Metropolitan Planning Commission

Staff Reports

January 24, 2008

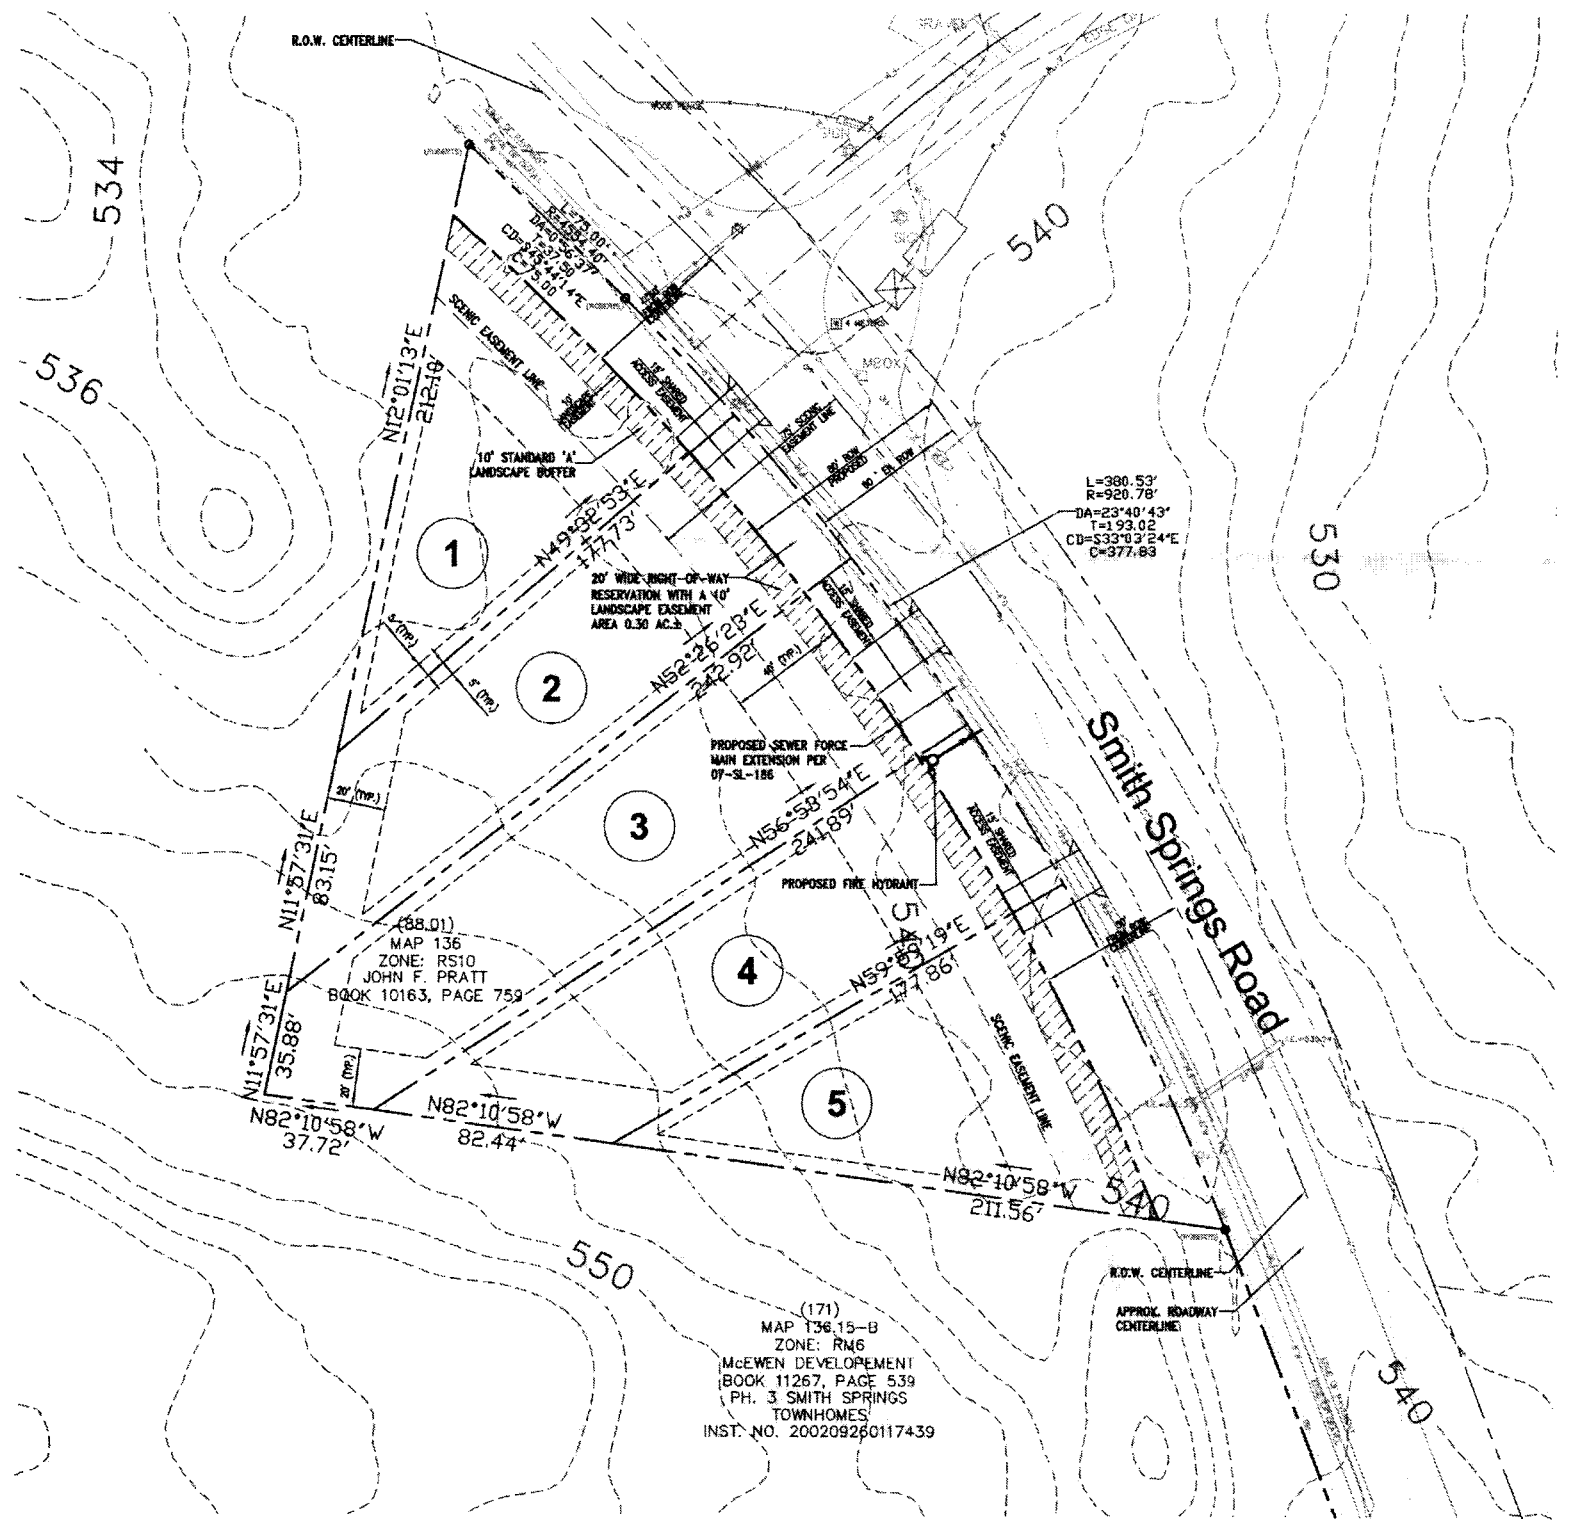
Section 3-8.2 of the Metro Subdivision Regulations requires sidewalks on existing streets fronting the property that is to be subdivided. The applicant is requesting a variance to this regulation citing the disruption of the existing drainage pattern along Smith Springs Road. The applicant further states that the drainage along Smith Springs Road is best achieved with roadside ditches as currently designed and the construction of a sidewalk would interfere with the design by requiring additional grading and tree disturbance.

This site falls within the Urban Services district, where sidewalks are required by the Subdivision Regulations along existing roads. The applicant's justification for the sidewalk variance does not meet the requirements for a variance. Roadside ditches exist along many roads in Davidson County. The conditions upon which the variance is requested are not unique to this property. As a condition of approval, sidewalks shall be installed within the existing right of way along Smith Springs Road.

requires that the setbacks along such designated roads be platted by measuring the applicable zone district required yard from the scenic landscape easement line. The applicant is requesting a variance to this section of the regulations, stating that the 40 foot setback from the scenic easement takes away valuable building area, particularly from lots 1 and 5 where the proposed triangular shape of each lot limits the buildable area. The applicant states that the configuration of the lots will likely require specialized floor plans or a reduction in the number of buildable lots.

In evaluating the variance to the setback line measurement, there are no physical characteristics or topographic conditions that present challenges to developing the site. Even with the 40 foot setback line measured from the scenic easement, the site can be configured to get the maximum number of lots possible. Staff recommends disapproval of the variance request to avoid the scenic route setback requirements. As a condition of approval, the setback line shall be measured from the scenic landscape easement line.

The granting of a variance must be based solely on extraordinary hardships that result from strict compliance with the Subdivision Regulations. The applicant, however, has not identified any particular unique conditions or characteristics associated with this property that create an undue hardship. To ensure continuous harmonious development along Smith Springs Road, it is important to establish a precedent of adhering to the sidewalk and setback line requirements at this site, so that any future development will comply with these regulations, and the need for similar variance requests will be eliminated.

1. Show a sidewalk within the existing right-of-way along Smith Springs Road.
2. Show the setback line measured from the scenic landscape easement line.
3. Pursuant to 2-3.4.e of the Metro Subdivision Regulations, if this application receives conditional approval from the Planning Commission, that approval shall expire unless revised plans showing the conditions on the face of the plans are submitted prior to any application for a final plat, and in no event more than 30 days after the effective date of the Commission's conditional approval vote.

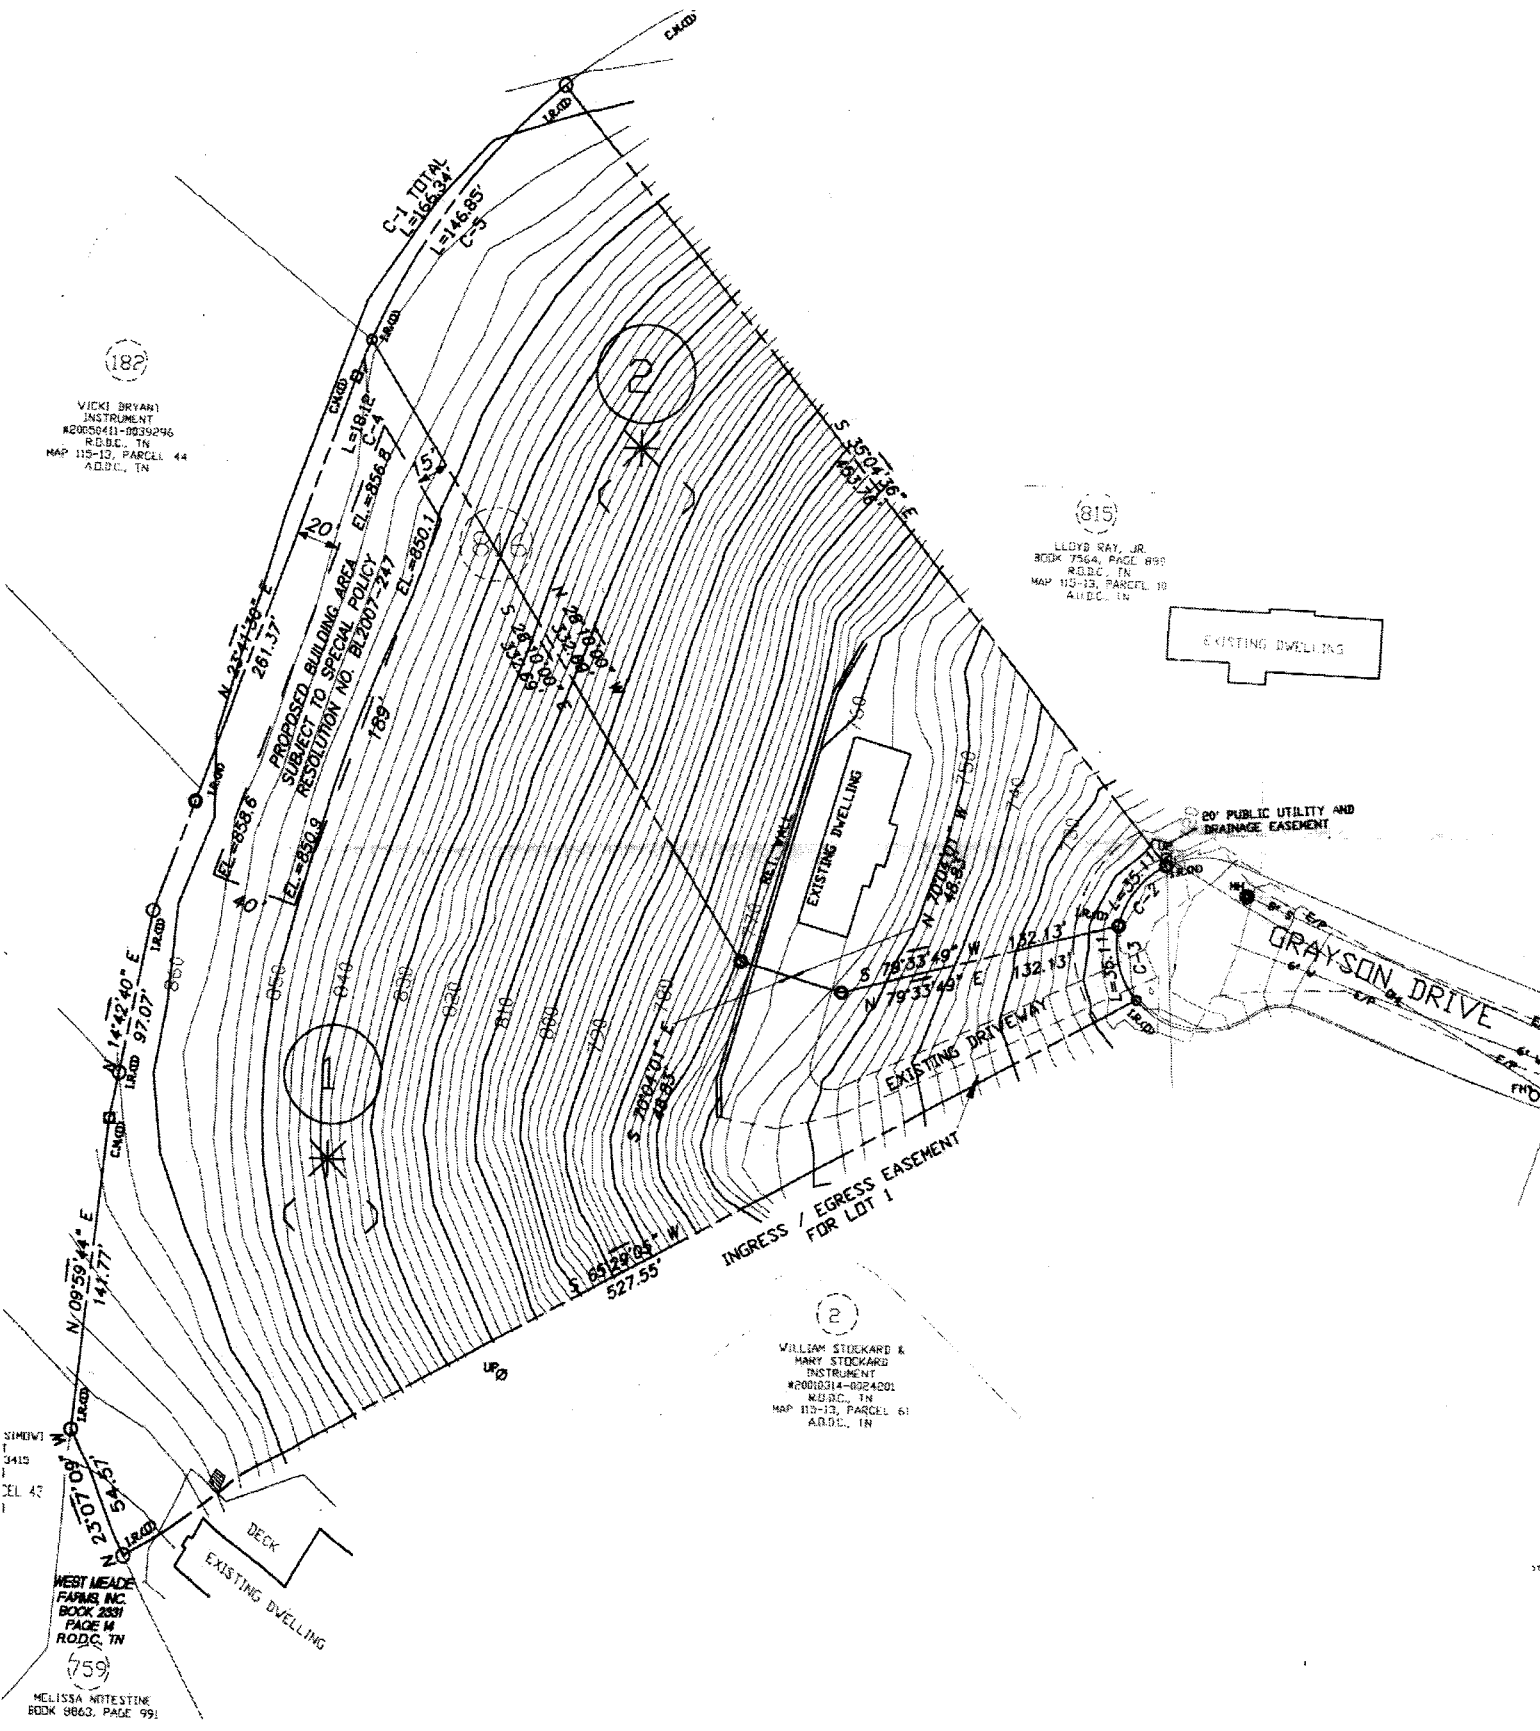
the residential design that blends with the surrounding natural environment.” The lot which is requested to be subdivided contains part of the major ridgeline and part of View Shed Area 2. It also contains steep slopes, which is defined as an area containing a slope of 20 percent or greater and sensitive soils. The applicant was asked to provide information to demonstrate that the two proposed lots could comply with the special policies. Staff has not received any additional information.

The western portion of the site is within the major ridgeline and View Shed Area 2. The area in the middle of the lot, adjacent to the existing driveway and proposed shared access point, is Bodine-Sulfura (BsE), a problem soil identified by the special policy and the Metro Zoning Ordinance and contains a slope of over 40%. The applicant has submitted a critical lot plan that shows the proposed building site for Lot 1 on top of the ridge line and proposed driveway, which is not contained on Lot 1. The applicant has not submitted a grading plan, as requested, to show that that the proposed building site and driveway comply with the development guidelines in the recent plan amendment.

Section 3-4.2.a of the Subdivision Regulations requires regular lot lines. The lot line between the two proposed lots is irregular. The applicant indicated that this was necessary in order to preserve the existing structure. The plan that has been submitted shows the proposed structure above the existing structure on a slope of approximately 40% that contains problem soils. Staff has grave concerns about placing a new home in this location.

Section 3-3.1 of the Subdivision Regulations states that land which the Planning Commission finds to be unsuitable for subdivision or development “shall not be subdivided or developed unless adequate methods to solve the problems created by the unsuitable land conditions are formulated by the developer and approved by the Planning Commission.” Steep slopes and problem soils are two of the features that may deem land unsuitable.

4. Submit a revised plat with the following corrections:
 - Add parcel numbers.
 - Correct square footage calculations for lots.
 - Correct label for ingress/egress easement.
 - Add subdivision number.
